**RE: Response Letter 2 – TAC Comments
3400 Lafayette Road, Portsmouth, NH
Tax Map 297, Lot 11
JBE Project No. 20737**

Jones & Beach Engineers, Inc., is in receipt of comments from the TAC members dated July 6, 2021. Original review comments are italicized, and we offer the following responses below:

RESIDENTIAL CONDOMINIUMS
TAX MAP 297, LOT 11
3400 LAFAYETTE ROAD, PORTSMOUTH, NH

DRAWING No.
OVR
SHEET 6 OF 26
JBE PROJECT NO. 20737

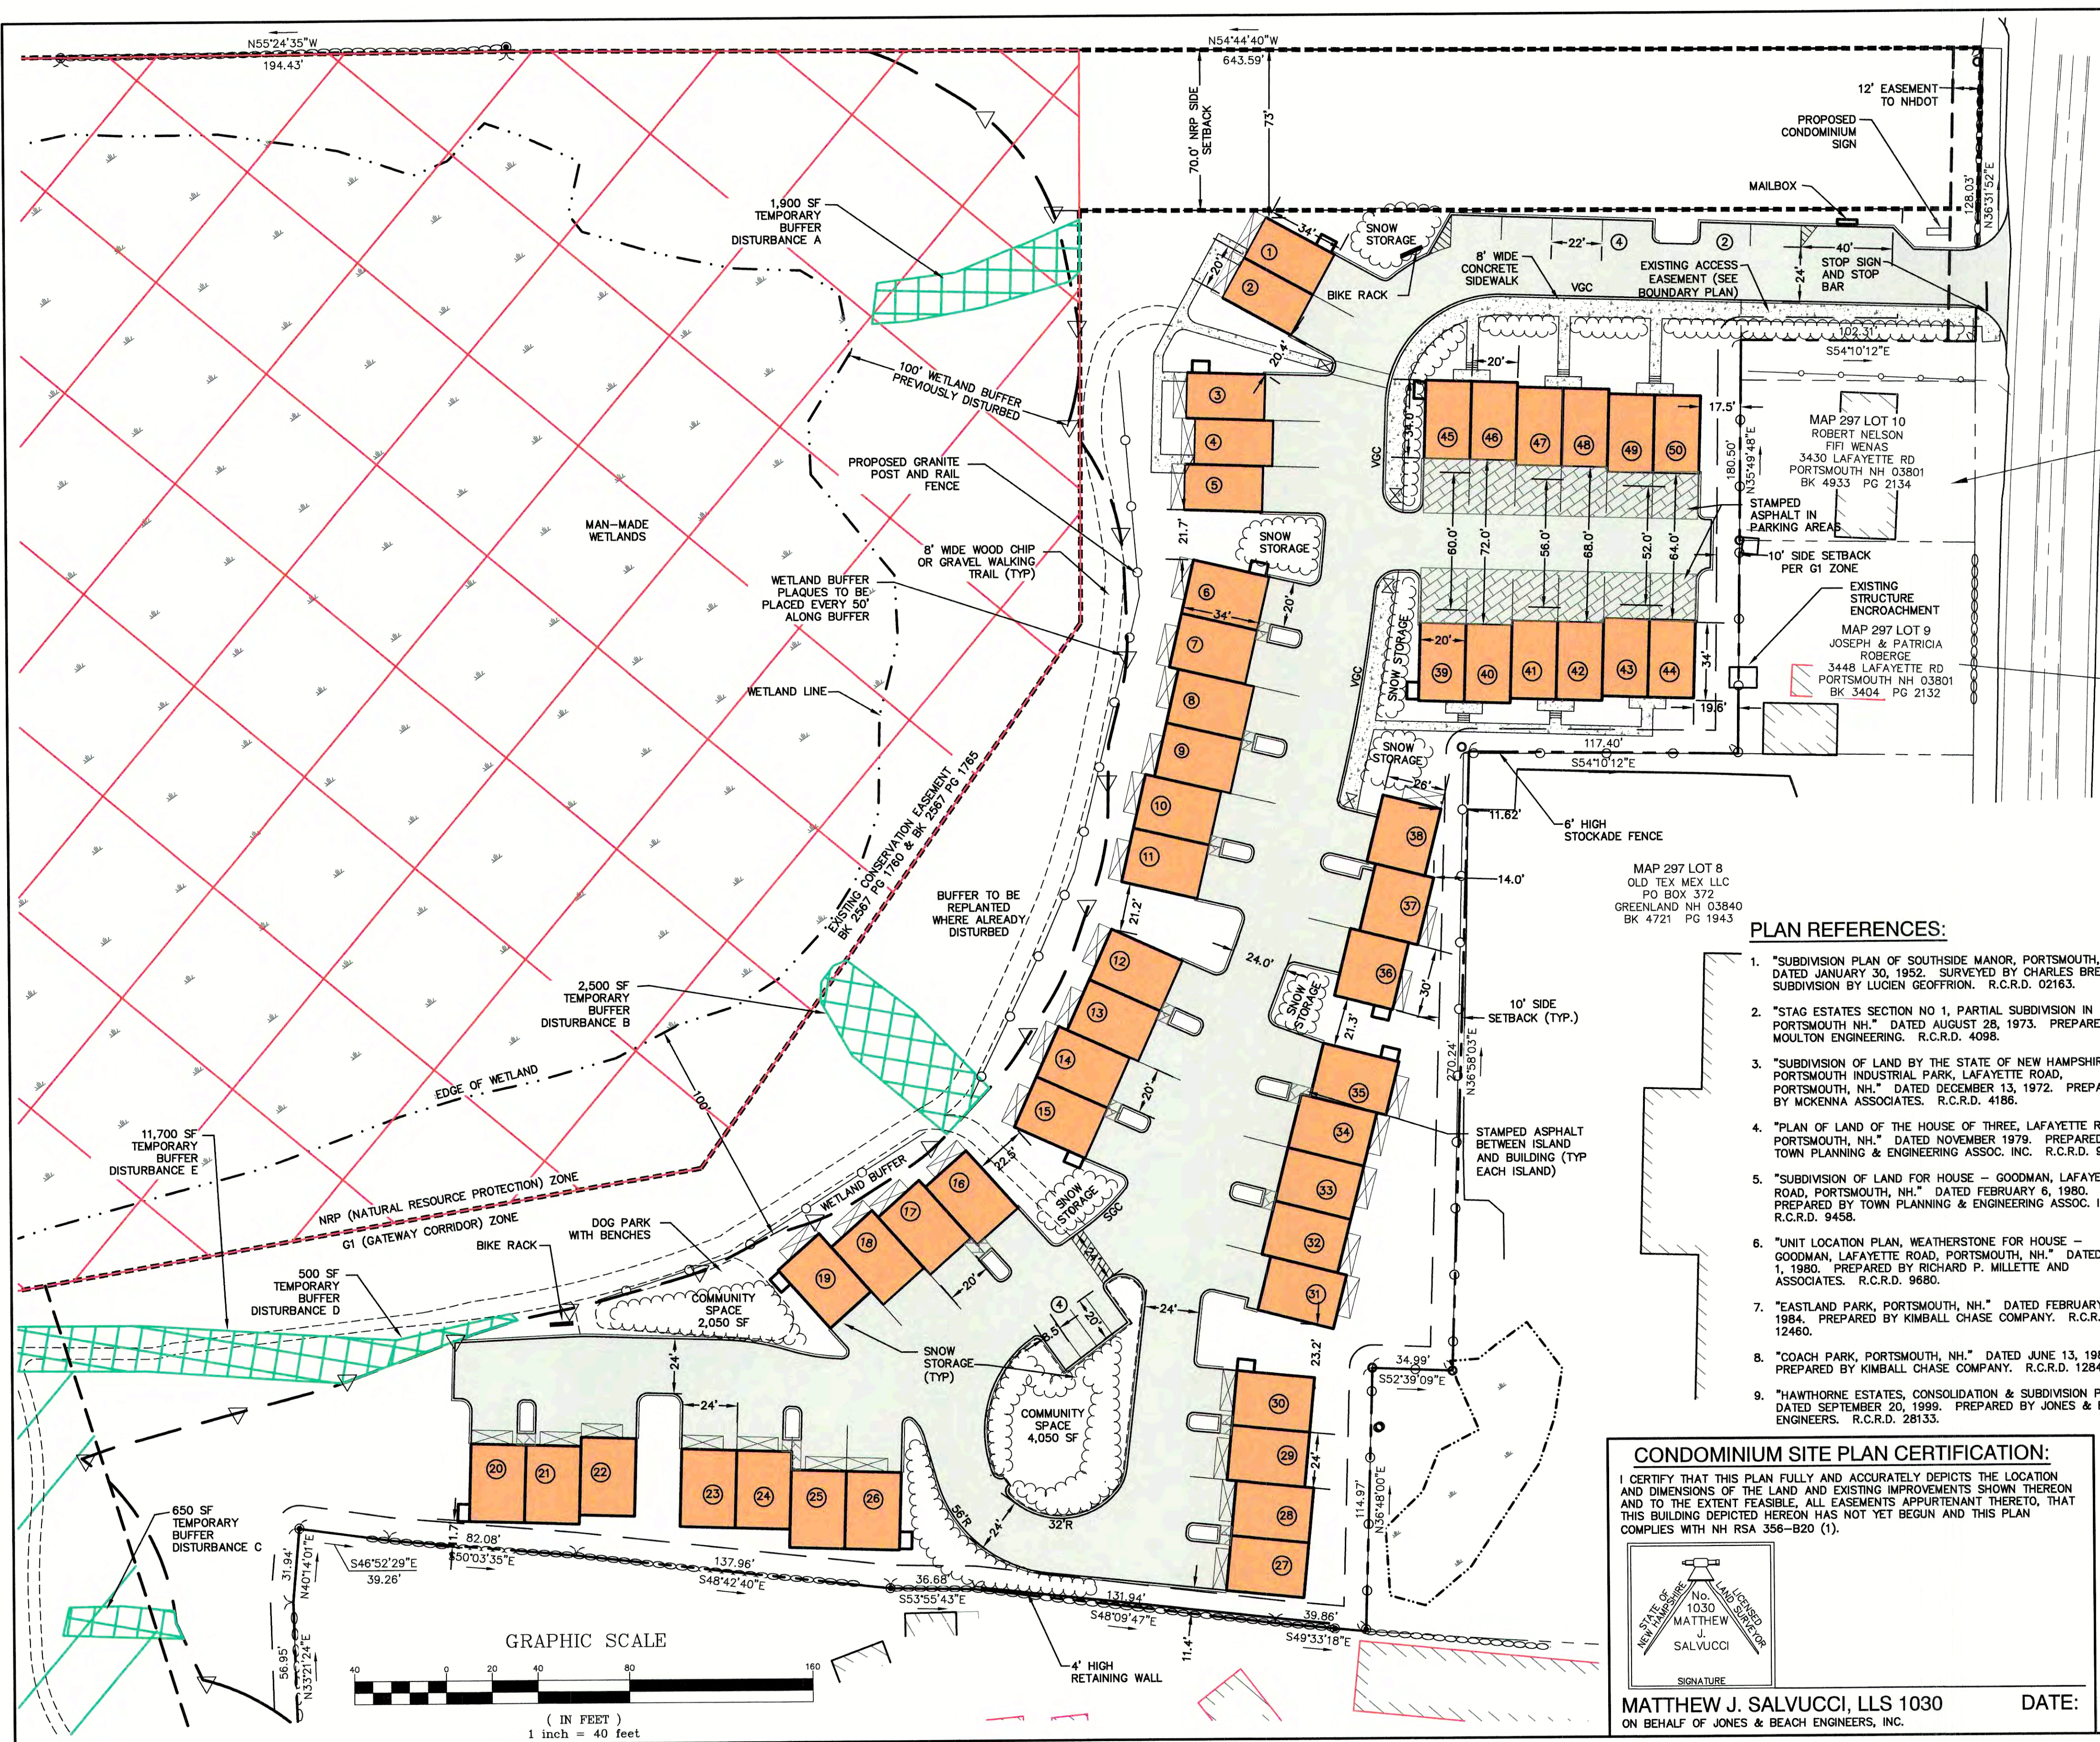
- d. *Please identify which types of community space you are proposing (see section 10.5A.45 of the Zoning Ordinance).*
RESPONSE: Community Space table has been provided on sheet OVR.

Drawing No.	C2
SHEET 7 OF 26	JBE PROJECT NO. 20737

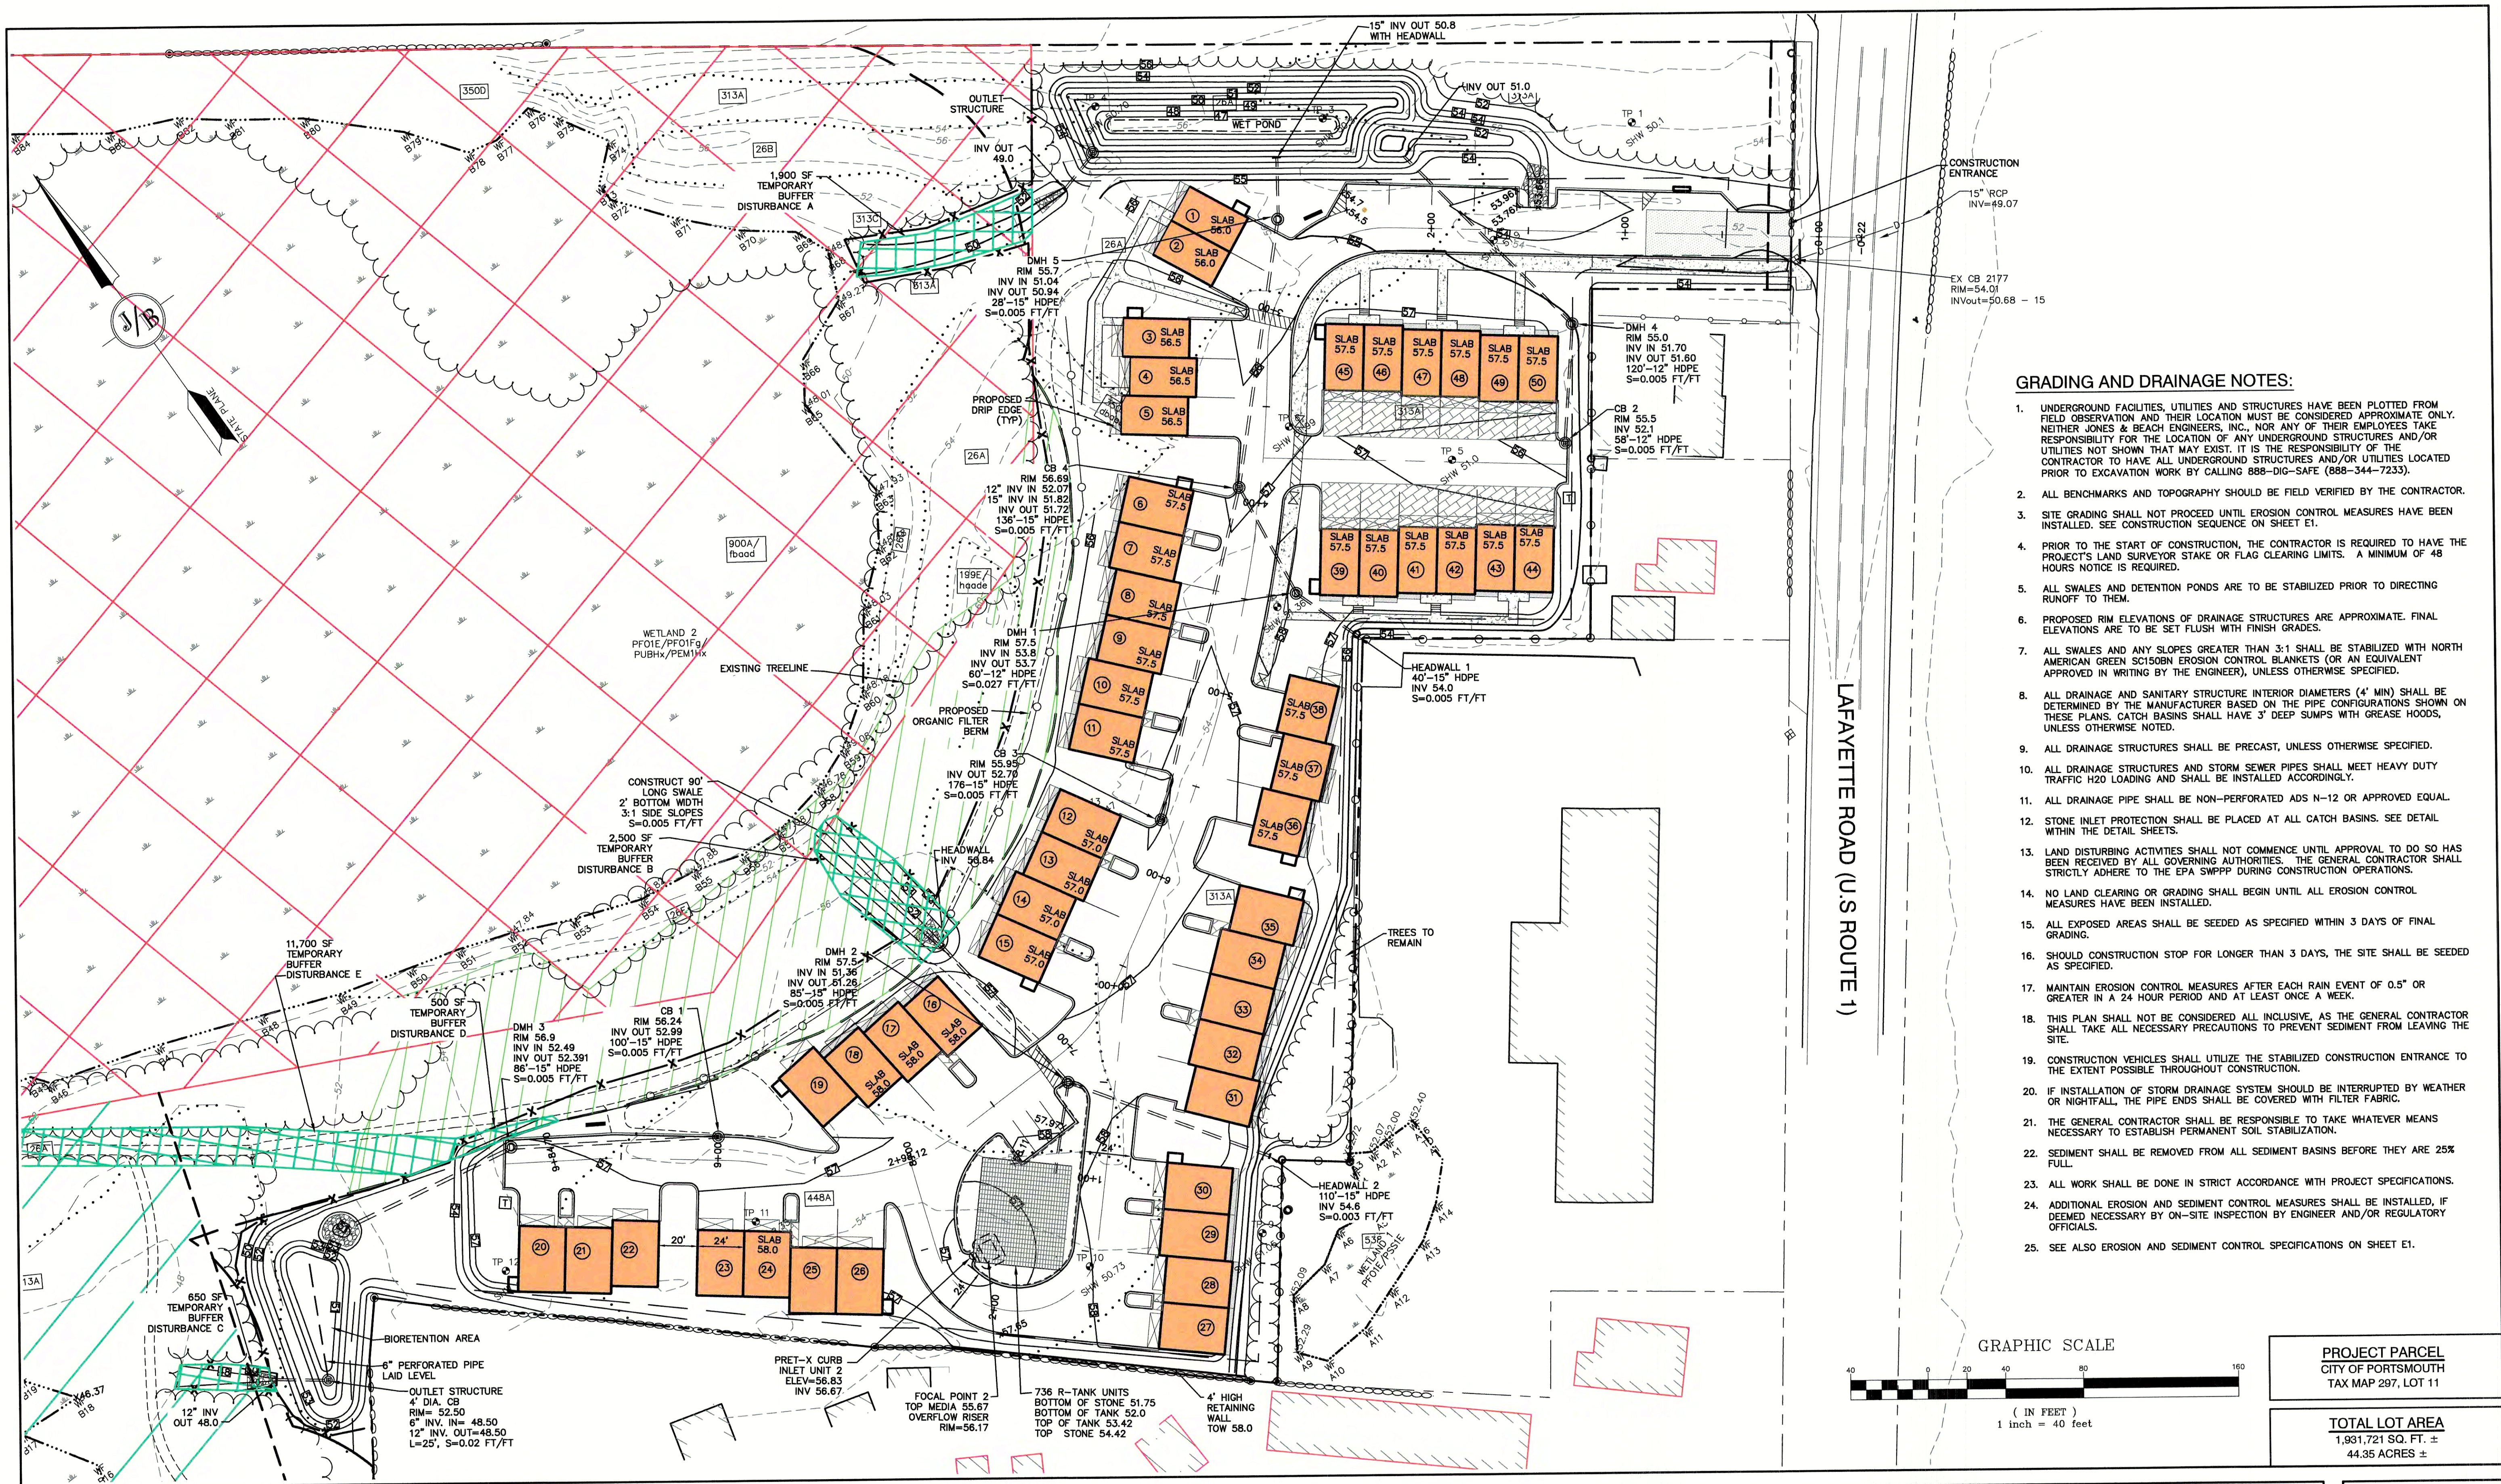
- h. *Per Section 10.1112.32 of the Zoning Ordinance, you are required to provide 10 visitor spaces (1 for every 5 dwellings) Please explain how you propose to satisfy this requirement?*

- k. *The stormwater for this site should not outlet into the wetland area that has been designed for mitigation. While the stormwater is being treated complete removal of all contaminants (i.e. chloride) is not possible with current technology. However, there will be impacts to this wetland area over the longterm if chlorine and other contaminants are allowed to be introduced to the wetland mitigation area.*

RESPONSE:. Visitor parking calculations have been added to Note #4 on Sheet C2.

RESPONSE: Green SnoPro note was already on Note #20 on sheet C2.

PORTSMOUTH BICYCLE RACK

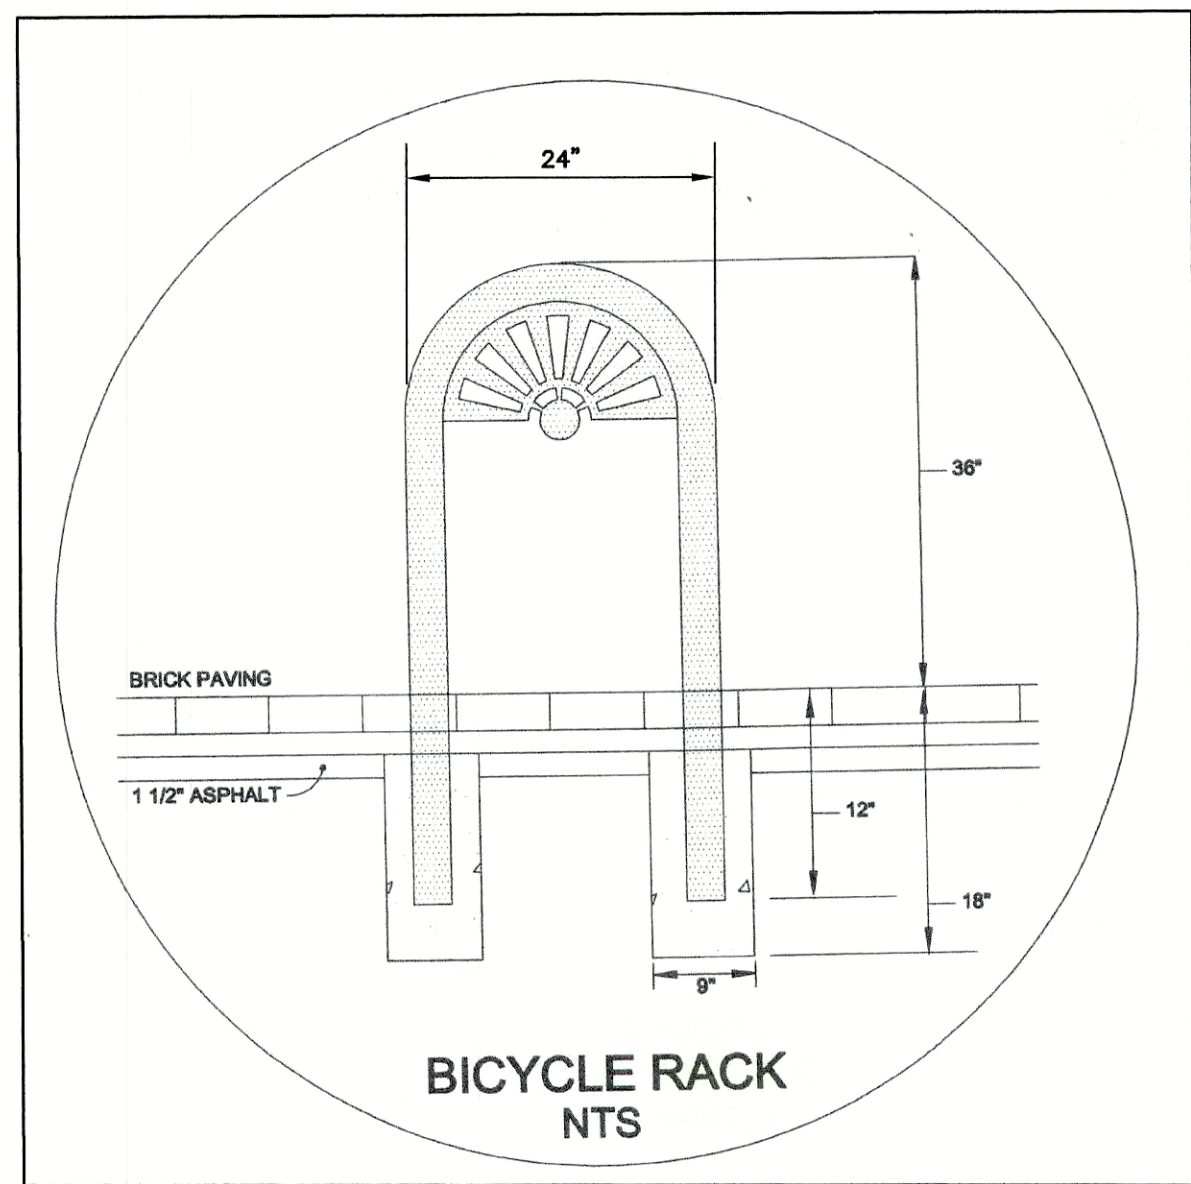
- e. *Please indicate how you are satisfying the requirements for provision of bicycle parking (see section 10.1116 of the Ordinance)*
RESPONSE: Bike rack locations and detail have been provided.

UTILITY TRENCH

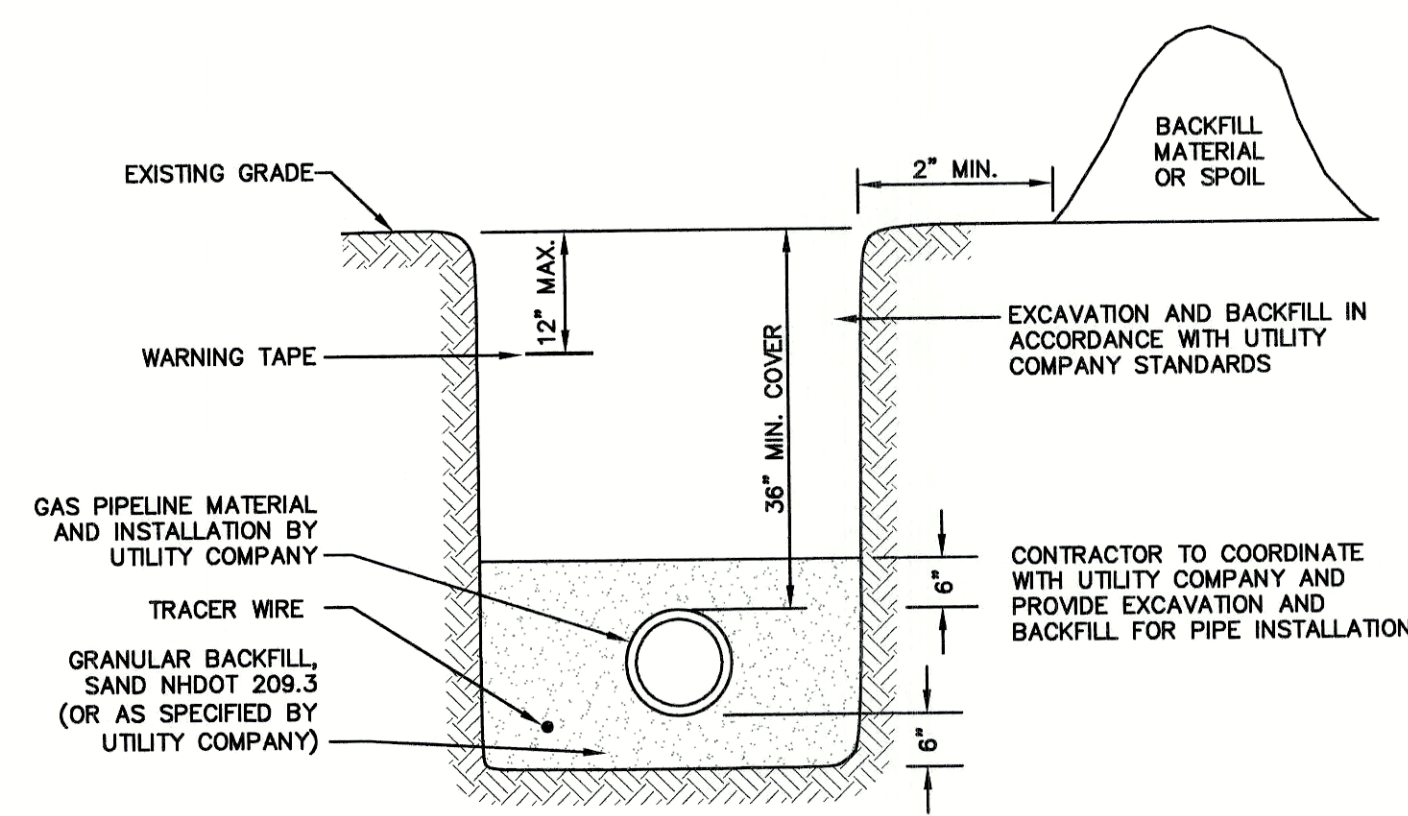
- b. *Water main pipe is required to be ductile iron. All valves and hydrants to open right.*
RESPONSE: The detail of the water trench has been updated to say ductile iron.
